REVISED CERTIFICATE OF APPROPRIATENESS

Property: 709 Highland Street, Tracts 14 & 15A, Block 33, Woodland Heights Subdivision.
The property includes a contributing 1,277 square foot two-story single family residence situated on a 5,000 square foot interior lot.

Proposal: Alteration—Amendment to existing COA approved administratively July 2021.

Proposed South Elevation (Front)

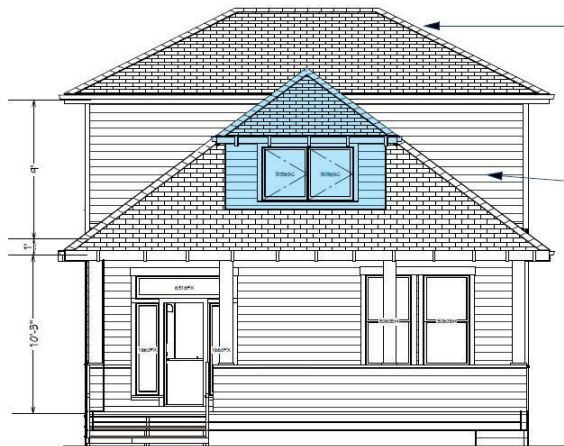
- Alter existing non-original dormer on south elevation by widening the dormer.
- Will replace single hung window with a single 36" x 43" casement window.

Recommendation: Approval

Photographs of inside attic

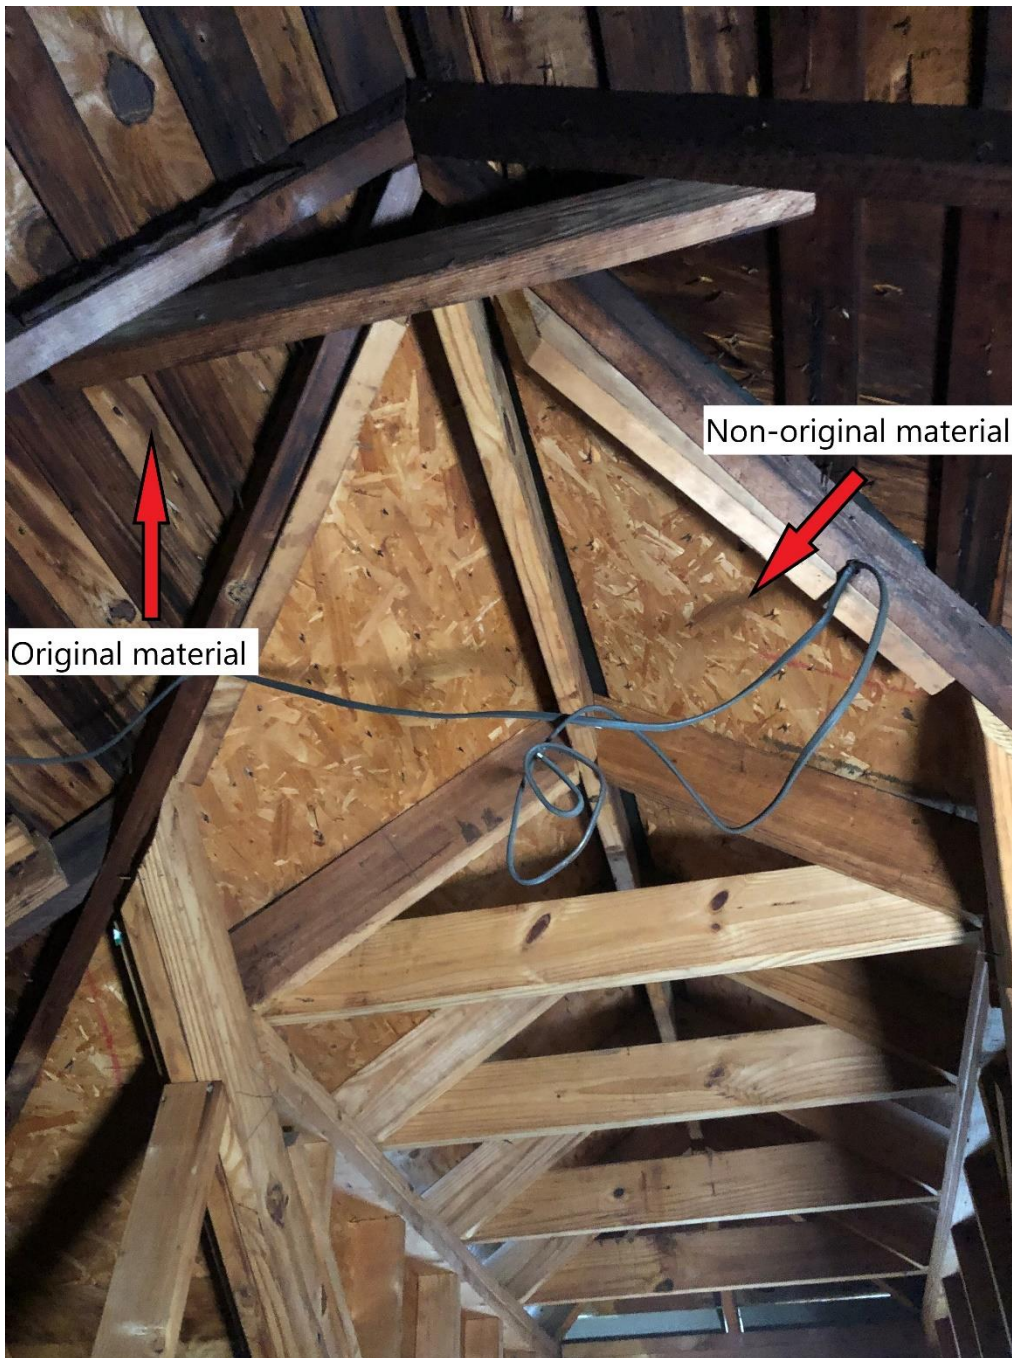
Photograph reveals the dormer was added at a later time

Photograph reveals the dormer was added at a later time
